Independent Review of Draft Cardno Report

Supply Mix Optimisation Model and Processes

SA Water

Ref No. 20130287RA1

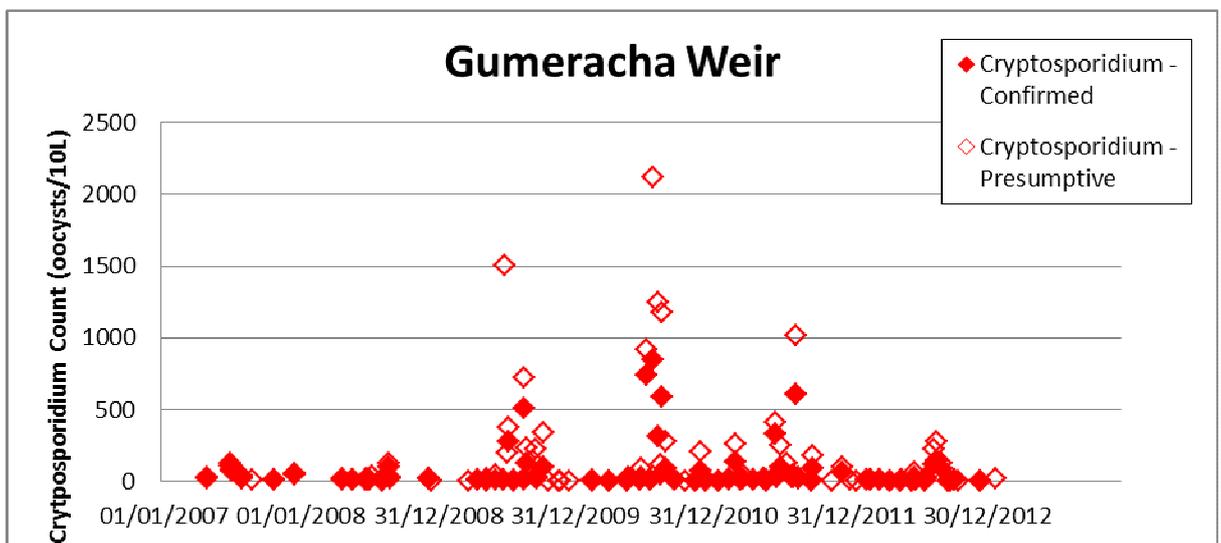
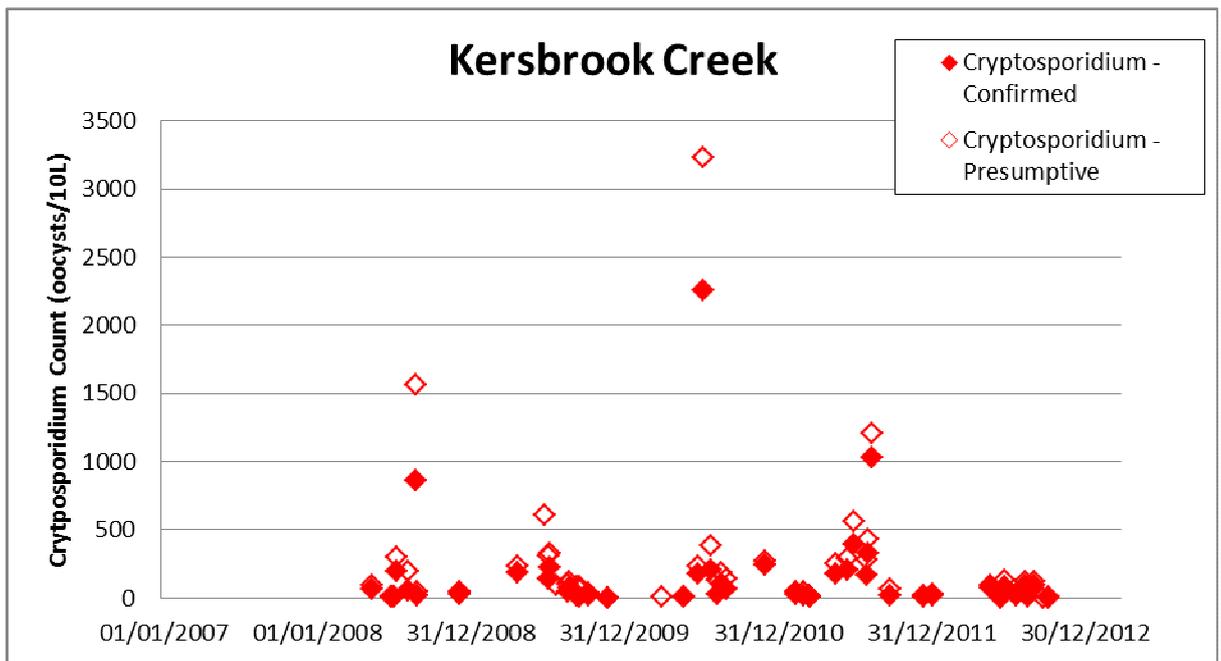
SA Water's Water quality monitoring records indicate that raw water inflows from Kersbrook Creek carry the highest *Cryptosporidium* loads of any reservoir inflow creeks monitored by SA Water (highest count to date was 2259 confirmed *Cryptosporidium*/10L which is a Department of Health and Ageing (DHA) Type 1 incident reportable both to DHA and the Minister for Water).

Graphical results showing historical detections of *Cryptosporidium* at key locations in the Torrens System (Kersbrook Creek (located approximately 650m upstream of Millbrook Reservoir) and Gumeracha Weir) and River Murray water pumped via the Mannum-Adelaide pipeline as recorded by SA Water are provided below.
